New Albany Planning Commission Meeting Amended Agenda

Wednesday, January 21, 2026, 7:00 p.m.

STACK DATA CENTER
FINAL DEVELOPMENT PLAN

Planning Commission Staff Report
January 21, 2026 Meeting

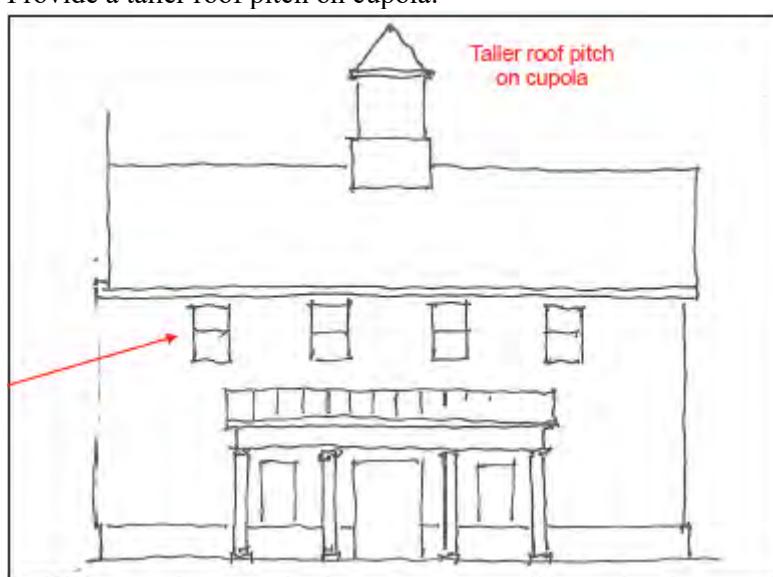
3. The applicant is proposing a pedestrian connection from the leisure trail into the site.
4. A four-rail horse fence is required to be installed, and it is shown on the renderings but not on the site plan. Staff recommends a condition of approval that the proposed horse fence is shown on the site plan (condition #2).

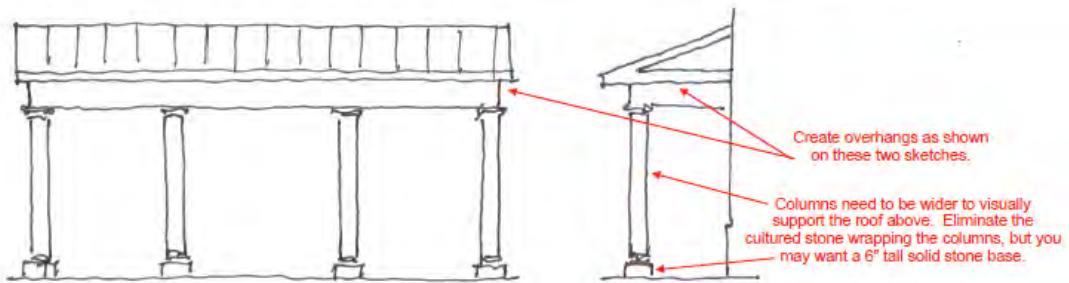
- o Provide a taller roof pitch on cupola.

- o Create overhangs as shown on the sketch below

- Columns should be wide to visually support the roof above. Eliminate cultured stone wrapping the columns and use a 6' tall solid stone base.
- Align neck of columns.

Image: Markup of condition #2.

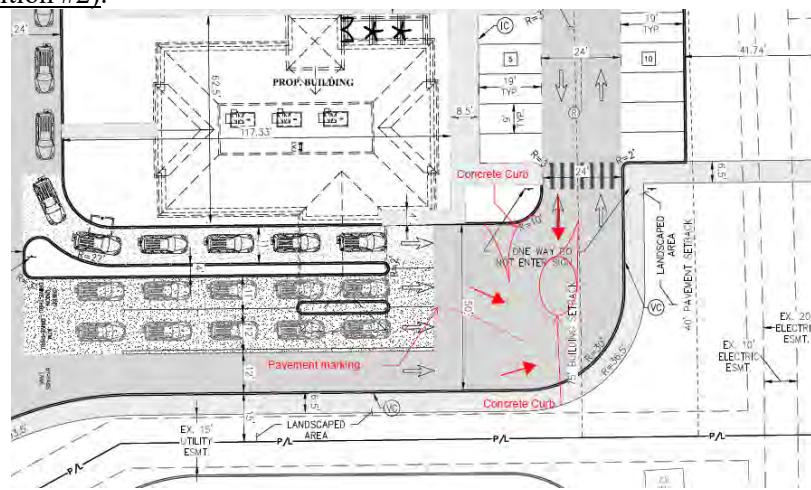
2. The city engineer comments that the one-way lanes could potentially conflict with southbound circulation and for cars backing out of the first parking space. To remedy this comment, staff recommends a condition of approval that a private traffic circle be added to the site as suggested in the engineering comments and exhibit (and image below). The curb should be six-inch mountable curbs so as to not negatively affect fire truck turning (condition #2).
